Cloud-Aerosol LIDAR and Infrared Pathfinder Satellite Observation (CALIPSO) Spacecraft

Independent Technical Assessment

Report of the ITA Findings to the NESC

ITA #: NESC-RP-001	
Requestor Name: William F. Townsend NASA Goddard Space Flight Center (GSFC) Deputy Director	Requestor Contact Info: (301)-286-5066 william.f.townsend@nasa.gov Code 100
Short Title: CALIPSO Spacecraft Proteus Propulsion System Assessment	
Description: Personnel hazards associated with Proteus Hydrazine propulsion bus once loaded (launch-36 days)	
Date Received: 10-22-03	Date ITA/I Initiated: 11-06-03
NESC Chief Engineer (NCE) Assigned: Michael Hagopian	NCE Contact Info: 301-286-6732
Lead Assigned: Dr. Richard J. Gilbrech	Lead Contact Info: 757-864-3303
Date ITA/I Concluded: 1-27-04

Figure 1. Schematic of CALIPSO Propulsion System

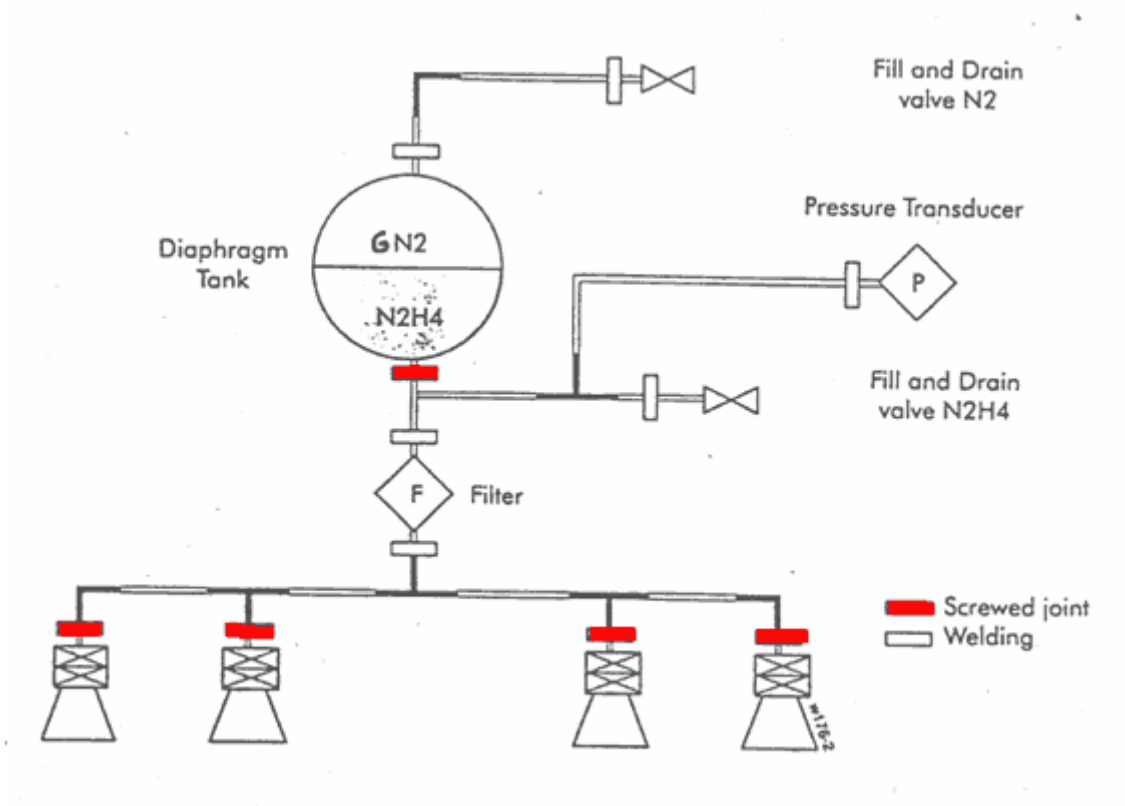
Three key issues have been highlighted: (1) use of mechanical fittings instead of welded joints for propulsion system fluid connections, (2) the potential for hydrazine leakage through thrusters and (3) the potential for inadvertent thruster firing. Personnel risks associated with these issues are:

- Toxic exposure to hydrazine leakage from the mechanical fittings
- Toxic exposure to un-reacted hydrazine in the thruster exhaust via leakage through the thruster valves or inadvertent thruster firing
- Fire potential from hydrazine leakage and subsequent contact with incompatible spacecraft materials
- Fire potential from thruster hot gas exhaust igniting combustible spacecraft materials

Figure 2. MS 33656 A/N fitting installation detail

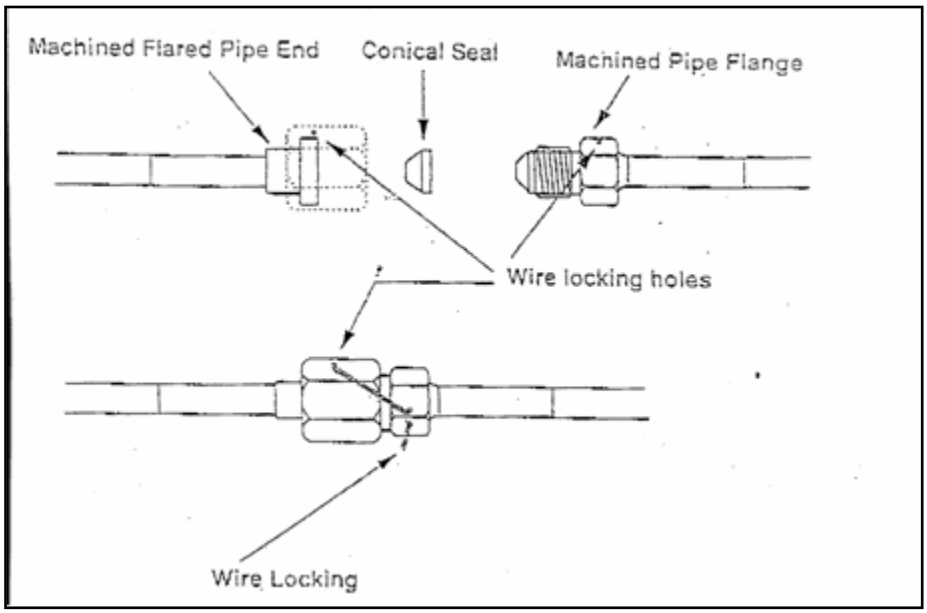
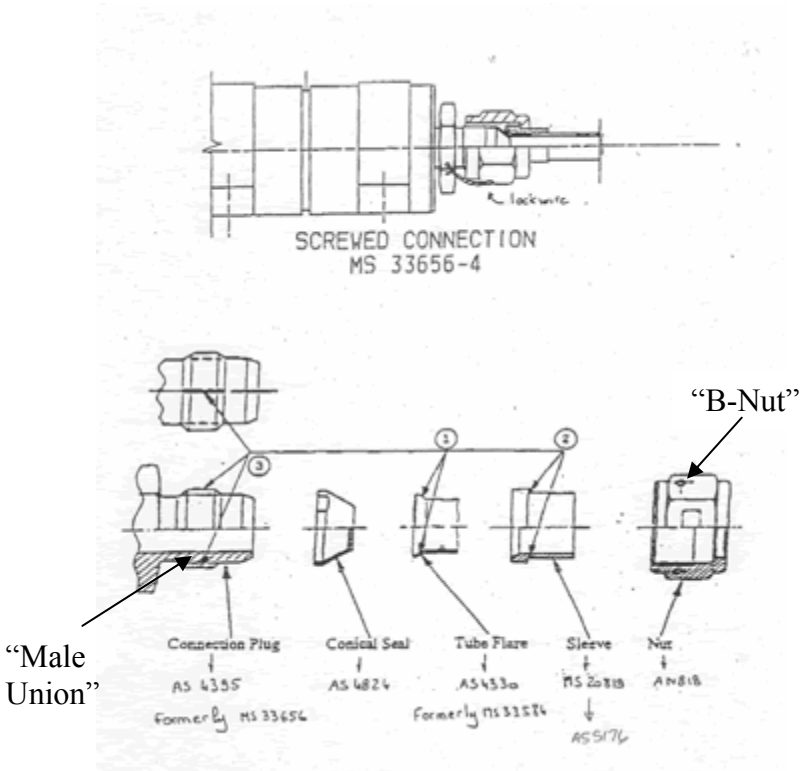
Properly welded fluid connections are inherently more reliable than mechanical fittings and should be incorporated in fluid propulsion system designs when possible. There are some circumstances, however, under which mechanical fittings offer an appropriate design solution. Ready interface to off-the-shelf parts, ease of maintenance, or potential for damage to soft goods during welding all may dictate use of threaded joints. MS-33656 type 37° A/N-fittings have been employed successfully in aerospace applications for many years and are acceptable for limited use providing they are (1) properly assembled, (2) validated by leak check as an assembly before use, (3) exposed only to temperature, pressure, vibration and shock environments for which they are certified, and (4) incorporate a secondary locking feature. The Proteus bus uses five such fittings; one at the hydrazine tank outlet and one at each of the thruster inlets (see Figures 2 and 3 for details). While lock-wire is used as a secondary locking feature, it is suitable only for preventing significant rotation of the B-nut and full disengagement of the fitting. Lock-wire alone will not prevent loss of joint preload[8] with subsequent reduction of clamping force at the sealing surfaces, and thus cannot be counted upon to prevent a fitting from leaking.

While the NESC was not provided specific qualification and acceptance test data for the CALIPSO Proteus bus, the NESC reviewed relevant test data from other propulsion system and component tests. In general these tests addressed qualification, acceptance and sensitivity of the MS-33656 type 37° A/N fittings for exposure to the environmental conditions of temperature, pressure, vibration, shock and assembly cycles. The following sections of this report summarize three test series conducted on the MS-33656 threaded fitting and the mitigating actions required to assure integrity of the CALIPSO Proteus bus fittings.

NESC-R-001 - Program shall demonstrate that Alcatel training and/or assembly documentation provided for proper lubrication of fluid fittings during assembly. Assembly procedures shall clearly delineate the type, quantity and location where lubricant was applied and ensure sealing surfaces were kept dry and free of any contaminant.

NESC-R-002 – Program shall demonstrate that Alcatel training and/or assembly documentation provided for a visual inspection of fluid fittings prior to assembly. Assembly procedures shall ensure components had no visible defects and sealing surfaces were clean and dry.

Figure 4. Moog Dual Seat Dual Servo Thruster Valve

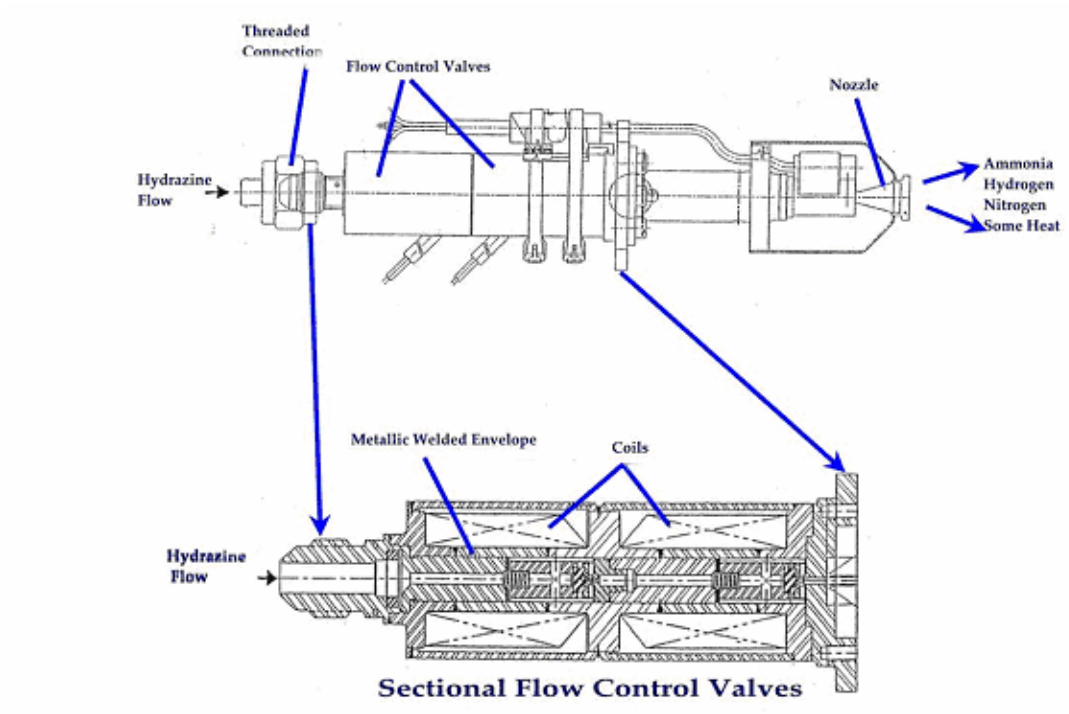
NESC concludes the potential for external leakage from the thrusters either internally (across the control valves) or externally (thruster casing or seal) poses acceptable risk to personnel providing the program conducts an adequate pre-servicing leak check of each valve. While the program did indicate such testing was planned, NESC was not provided a specific description of the test or its pass/fail criteria.

NESC-R-007 – Program shall demonstrate that pre-servicing thruster leak checks will be adequate to validate system integrity. Leak check procedures shall test each valve independently and shall specify test method, equipment to be used, media, test pressure and allowable leak rate.

NESC-R-008 Program shall verify that the Proteus Moog valves on CALIPSO do not have defective plunger assemblies.

Figure 5. Thruster Circuit Schematic with New Test/Arm Plugs (PM refers to spacecraft processor module)

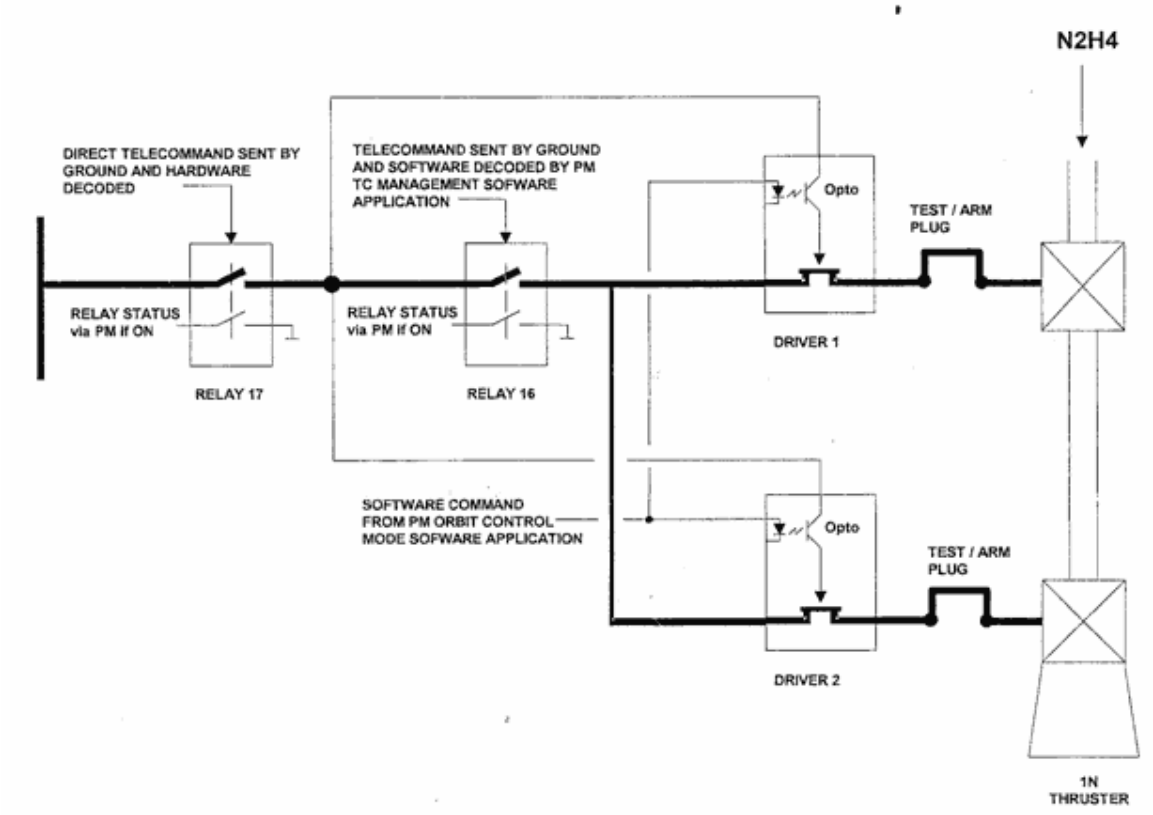
The Proteus thruster firing circuit incorporates a number of controls to ensure valves are not inadvertently opened causing a thruster to fire. NESC concurs the controls are adequate, but recommends further steps be taken to positively preclude the possibility of an inadvertent command during periods of dynamic testing, especially power-up. A schematic of the thruster wiring circuit is shown in Figure 5. It is worth noting that the Astrium specification sheet for the thruster lists nominal flow rate at 0.44 grams per second. Even with all four (4) thrusters firing at nominal flow rate, it would take 4.7 hours to drain the 30 kilograms of hydrazine in the propellant tank.

NESC-R-009 – Program shall demonstrate that test procedures verify relays 16 and 17 are open before power is applied to the spacecraft. Since the design incorporates latching relays, verification of the last stable state by data retrieval or written record is acceptable.

NESC-R-010 – Steps for inserting and removing test/arm plugs shall be explicitly called out in the ground processing timeline. Final installation for flight shall occur as late as possible; until that time, plugs shall only be installed as required for thruster valve testing.

NESC-R-011 – Program shall verify that all thruster firing circuit inhibits function as designed.
